Project No. 0771-356-11-41
June 5, 2023

Re: Response to 1st Technical Notice of Deficiency Letter – Major Permit Amendment Application
Fort Worth C&D Landfill
Fort Worth, Tarrant County, Texas
MSW Permit No. 1983E
Tracking No. 28325020

NOD1 Table - Permit Type IV (Permit 1983E)

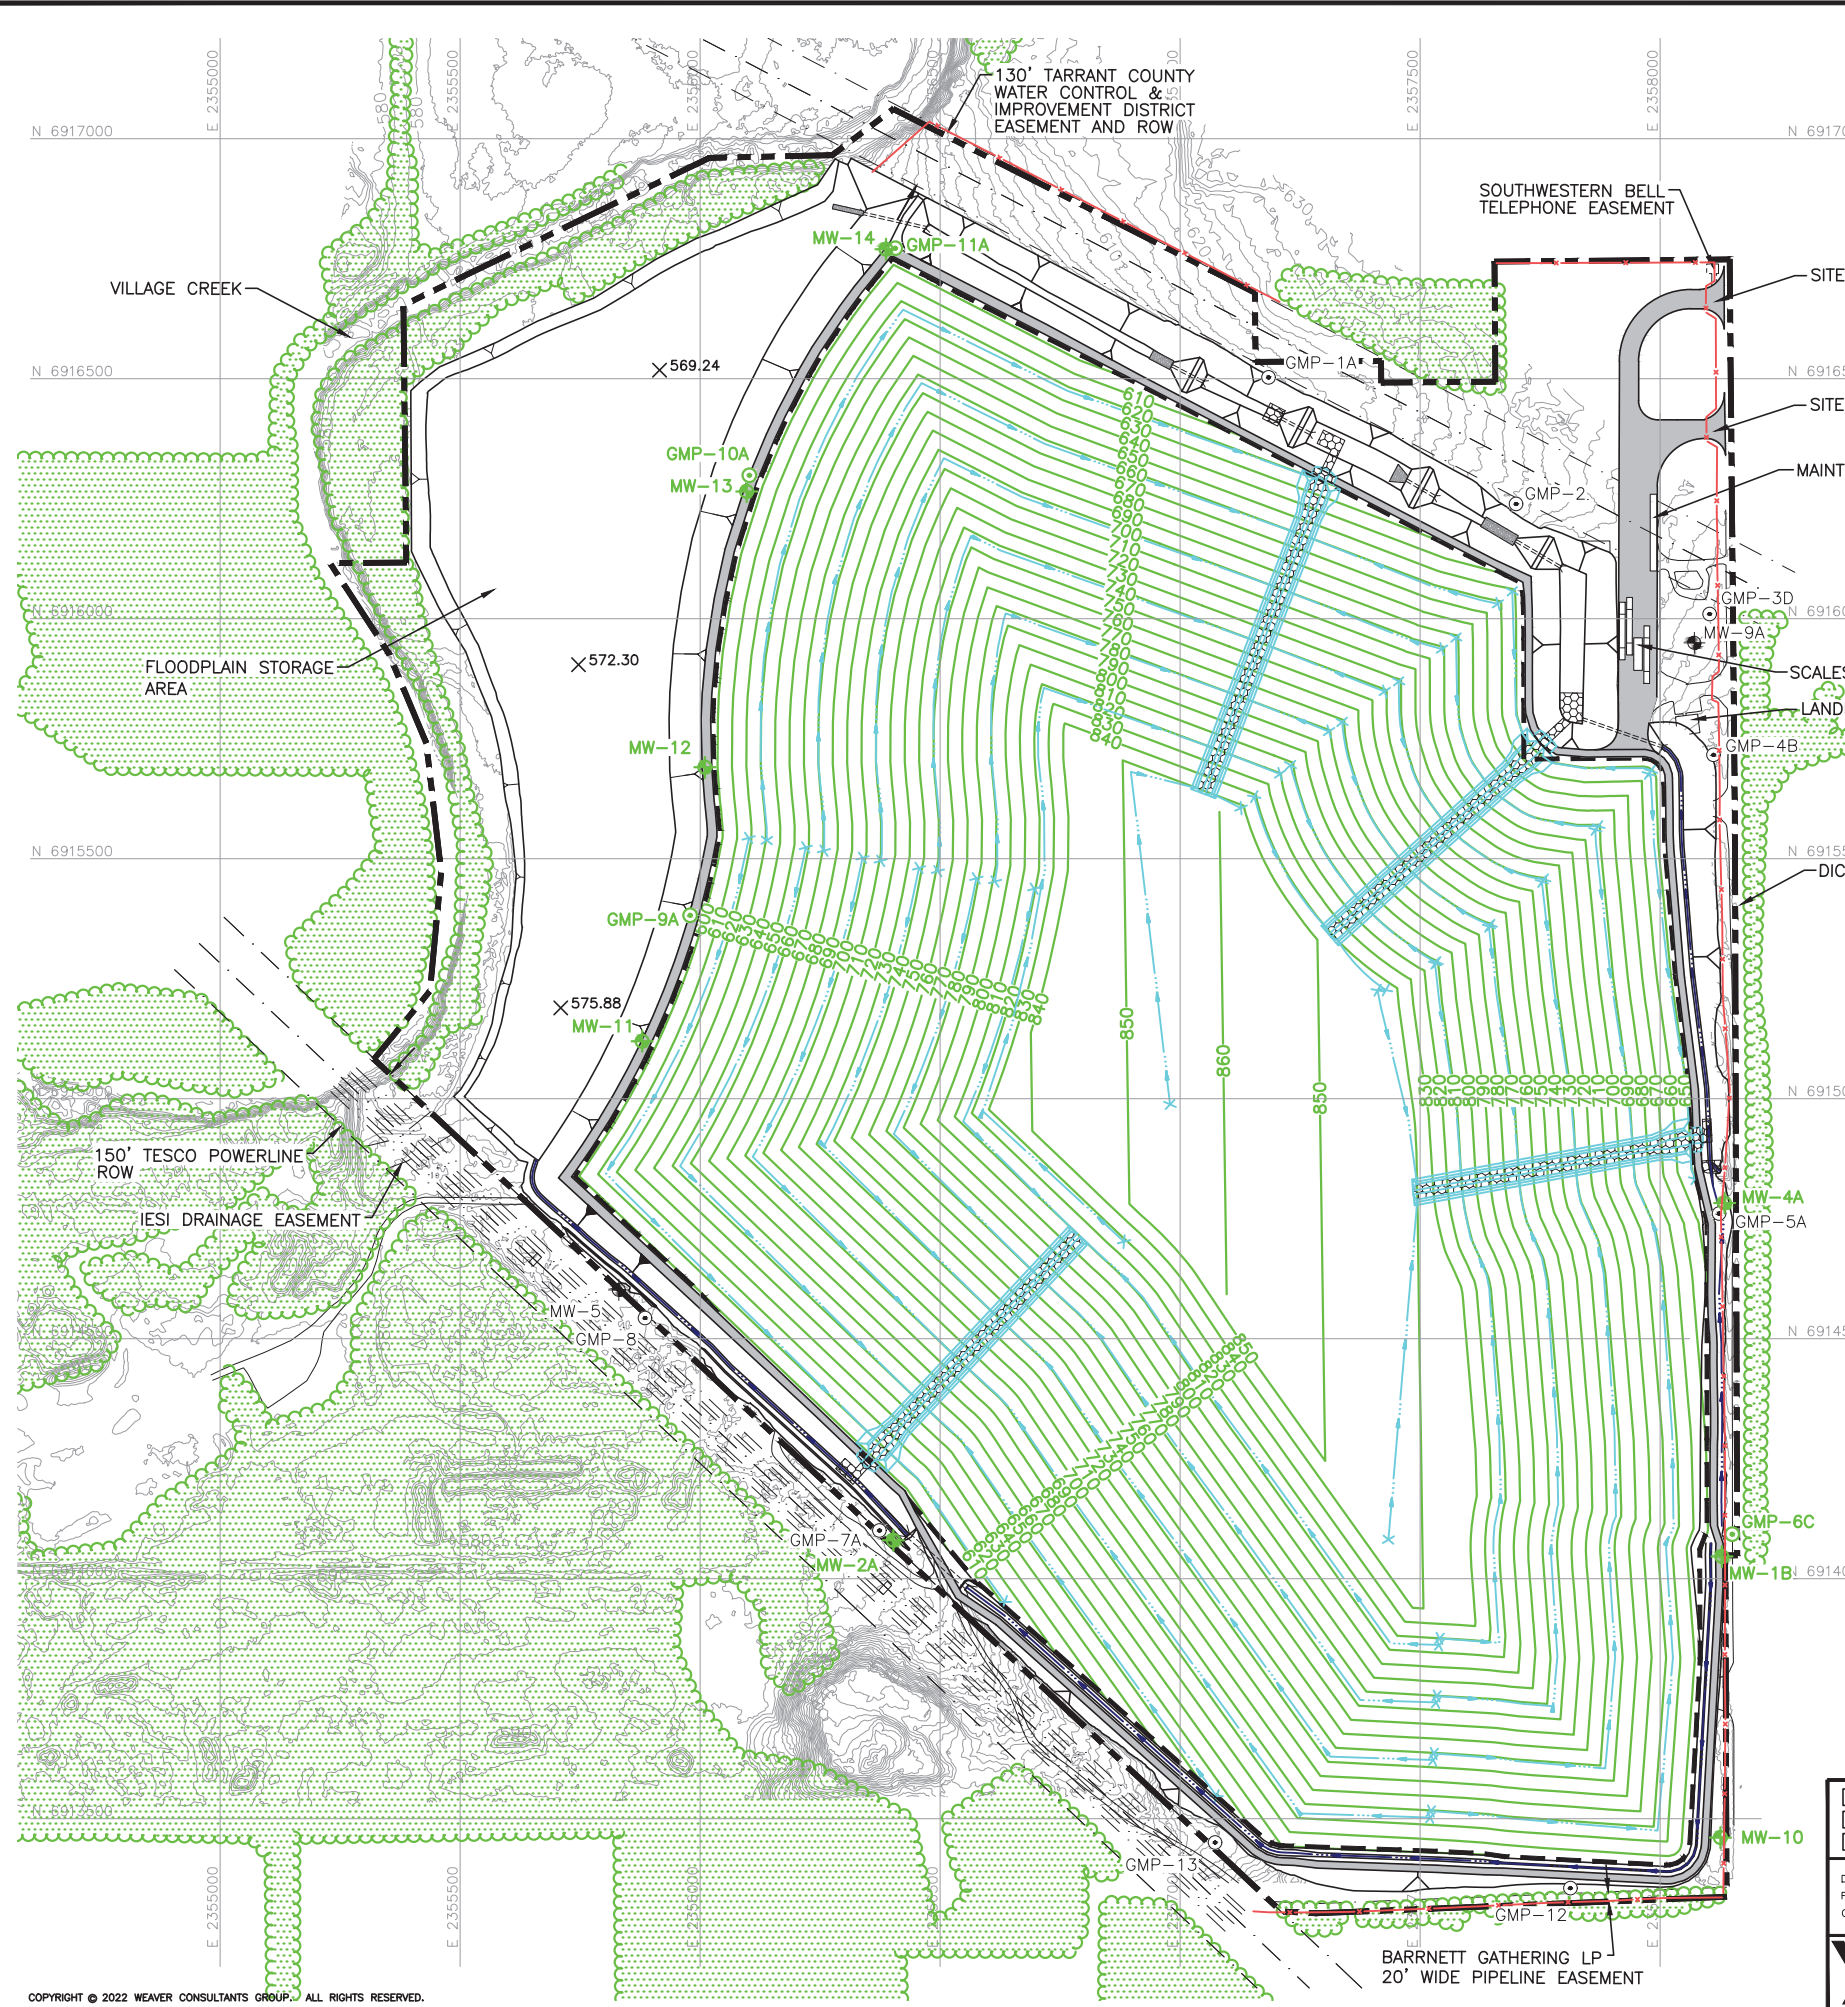
NOD ID	MRI ID	App. Part	Citation	1st NOD Type	NOD Description
T8	191	Part II	330.61(d)(7)	Incomplete	<p>Provide additional information and provide the location of facility windbreaks, greenbelts, and visual screening. Parts I/II, Figure I/II-A.11 Access Control Plan does not contain sufficient information.</p> <p>Response: The facility is bounded by trees/vegetation to the west, south, and east. The existing dense tree lines function as both windbreaks and site screening. Tree lines/vegetation will be maintained to avoid nuisance conditions and maintain effective visual screening. This information is included on Figure I/II-A.11, Note 3.</p>
T9	196	Part II	330.61(d)(9)(D)	Incomplete	<p>Indicate the dimensions of cells/ Sectors.</p> <p>Response: The dimensions of cells/sectors can be found on a scale drawing in Parts I/IIA, Figure I/IIA-A.2 Sector Development Sequence.</p>
NT10	229	Part II	330.543(a)	Incomplete	<p>Include a statement in Part I/IIC-10, Section 7 that no solid waste unloading, storage, disposal, or processing operations shall occur within any easement, buffer zone, or right-of-way that crosses the facility.</p> <p>Response: This statement has been added to Part I/IIC, Section 2 – Easements and Buffer Zones.</p>

- FACILITY IS BOUNDED HIGH-CANOPY TREE LINES. THE EXISTING DENSE TREE LINES FUNCTION AS BOTH WINDBREAKS AND SITE SCREENING. AS SHOWN IN FIGURE 1/II-A.2 SECTOR DEVELOPMENT SEQUENCE, THE LANDFILL IS SEQUENCED SUCH THAT THE ACTIVE FILL AREA WILL BE SCREENED BY THE EXISTING VEGETATION. THE FILL SEQUENCE WILL ALSO DEVELOP THE OUTERMOST SECTORS FIRST, WHICH WILL SCREEN SUBSEQUENT OPERATIONS. FACILITY IS BOUNDED BY TREES ON THE WEST, SOUTH, AND NORTH. TREE LINES WILL BE MAINTAINED TO AVOID NUISANCE CONDITIONS AND MAINTAIN EFFECTIVE VISUAL SCREENING.

REVISIONS			NO.	DATE	DESCRIPTION	1	06/2023	SEE LIST OF REVISIONS	FIGURE III-G-C-9	
REVISIONS														
NO.	DATE	DESCRIPTION												
1	06/2023	SEE LIST OF REVISIONS

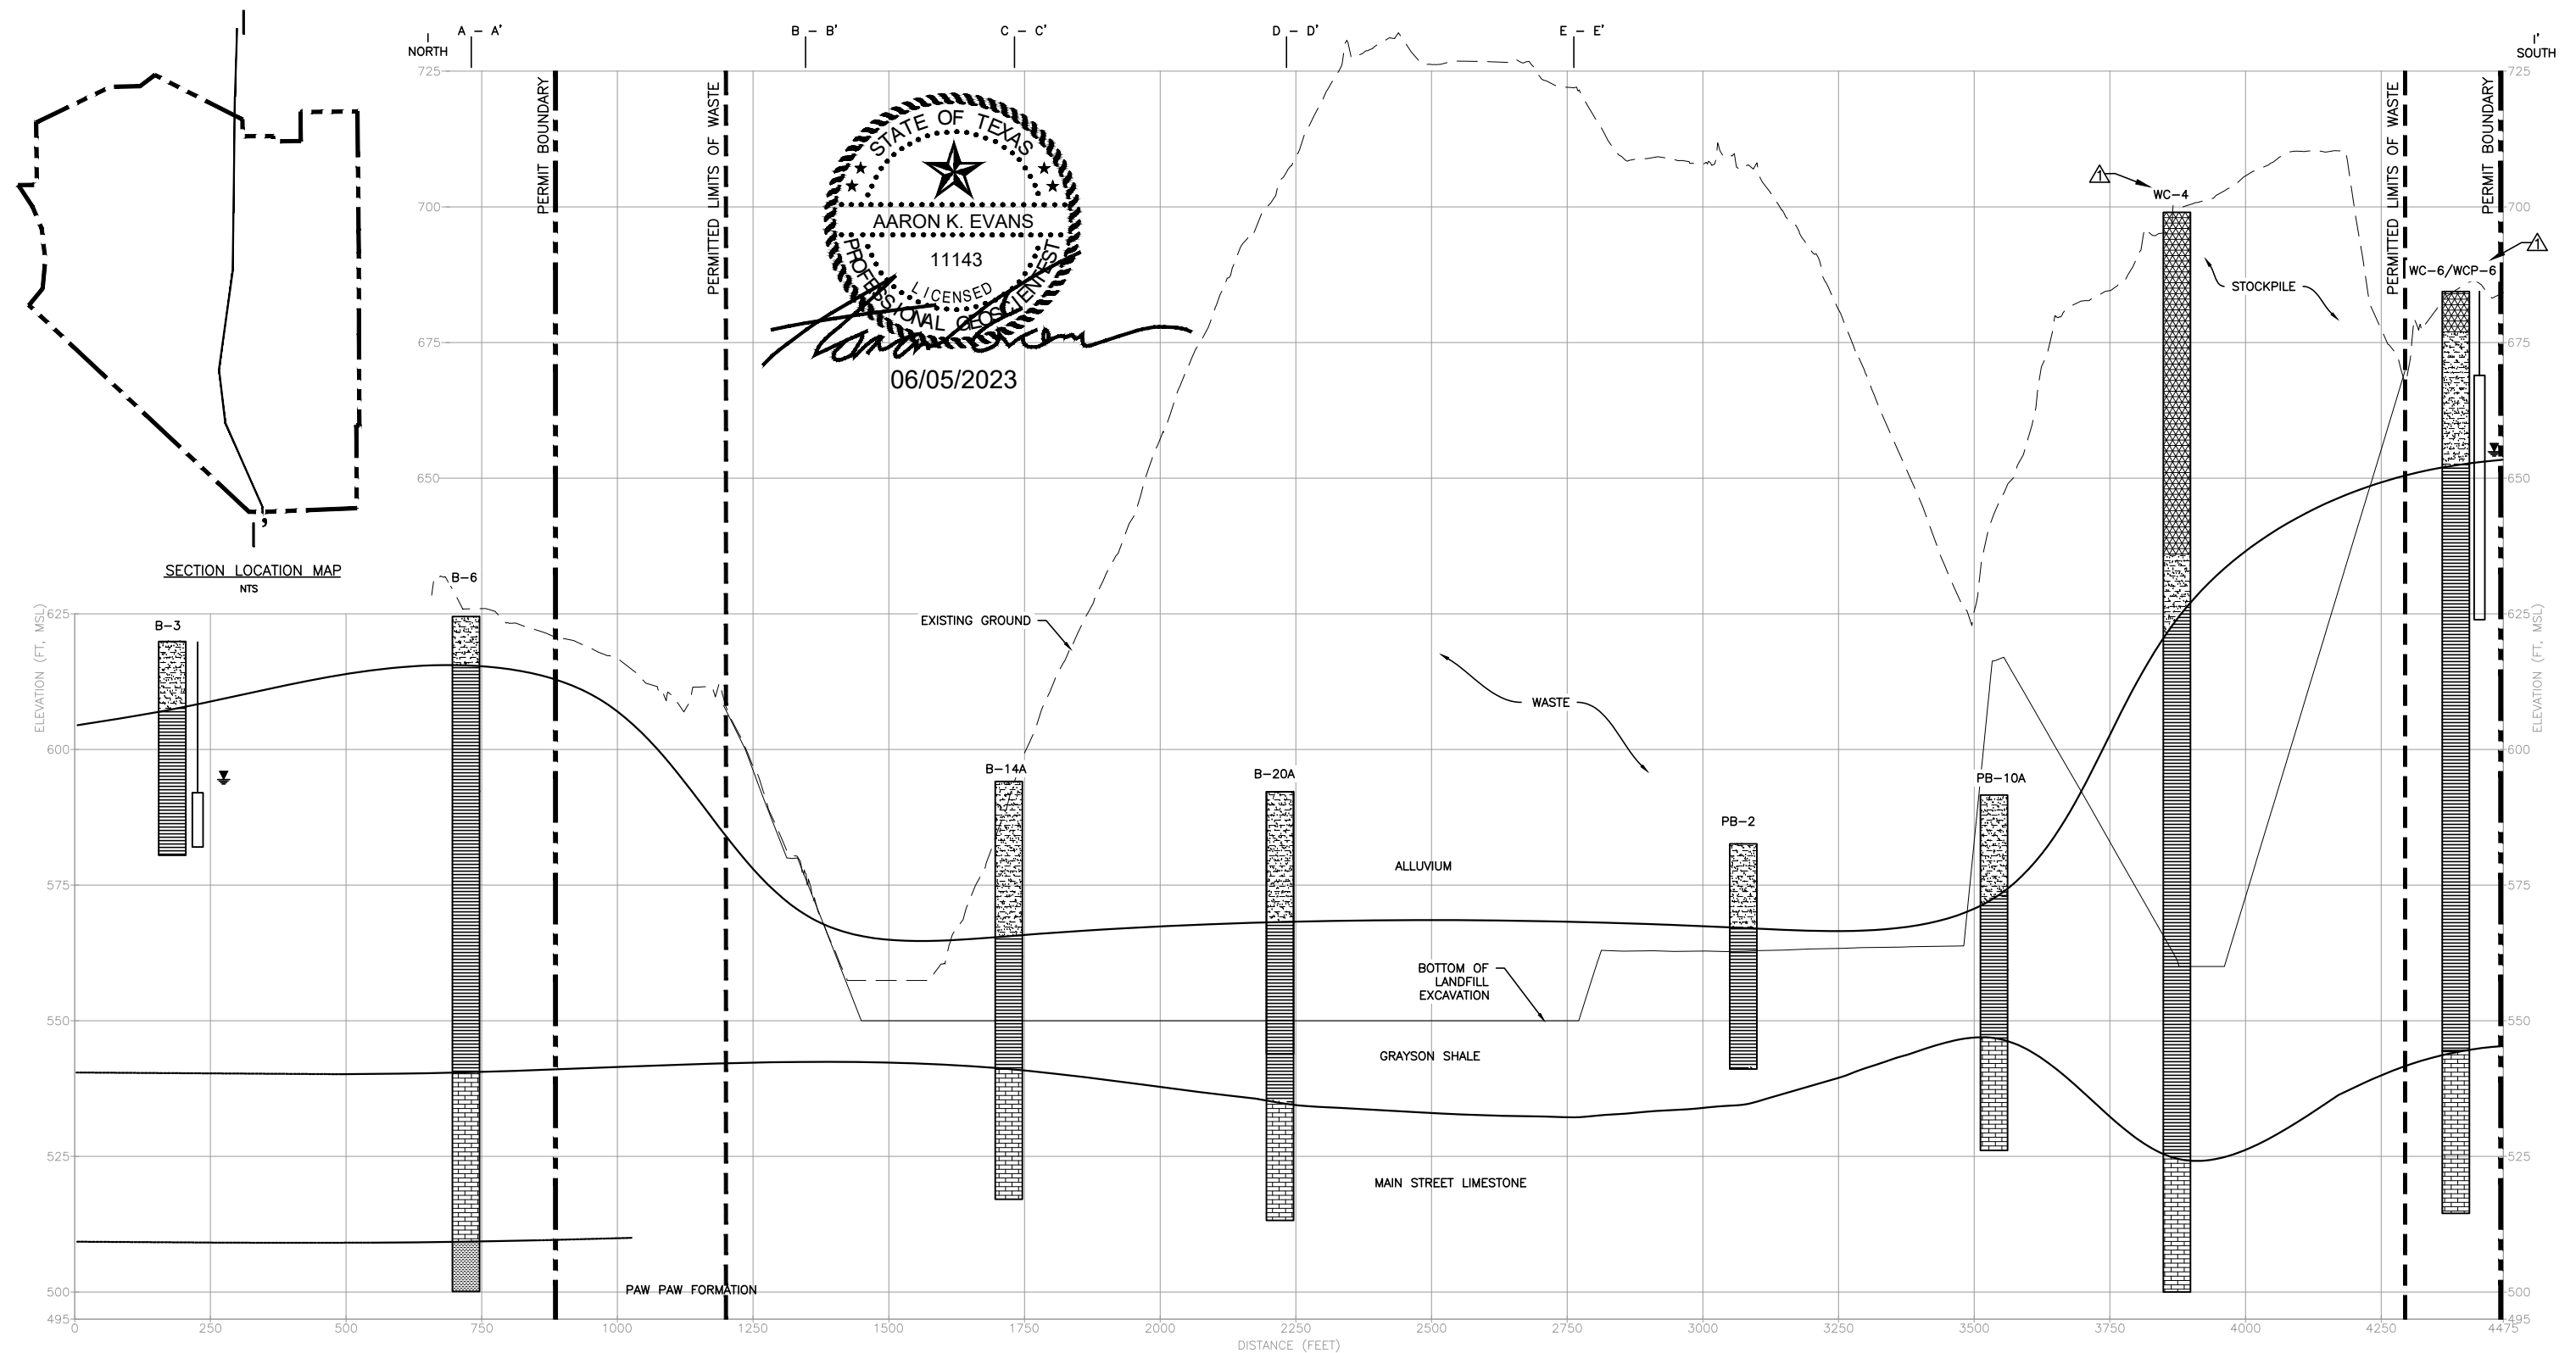
NOD ID	MRI ID	App. Part	Citation	1st NOD Type	NOD Description
T24	494	Part III	330.63(e)(4)(G)	Ambiguous	<p>Revise drawing IIIG-C-13 (Section L-L') for the symbols of alluvium in the logs and legend to be consistent.</p> <p>Response: Figure IIIG-C-13 has been revised to make the requested changes to section L-L'. Geologic section figures IIIG-C-3, IIIG-C-9, and IIIG-C-10 have also been revised to reflect updates to unconsolidated sediment graphics and differentiate between fill and insitu sediments observed at time of drilling in the 2018/2019 expansion borings.</p> <p>What is the current understanding of the transition "Woodbine - Quarternary Alluvium", specifically between boreholes WC-4 & 5 (shown in the drawing as a question mark)?</p> <p>Response: The extent of Woodbine Formation sediments was estimated from both the Regional Geologic Map (depicted on Figure IIIG-A-1) and the site-specific geologic data which is also consistent with the existing permitted subsurface characterization (Permit No. MSW-1983D) and the former subsurface characterization (Permit No. MSW-1983C). The question mark symbol depicted in cross section drawings serve to indicate that horizontal contacts of Alluvium-to-Grayson-to-Woodbine are not precisely known within the southernmost facility area due to previous excavation and stockpiling activities.</p>
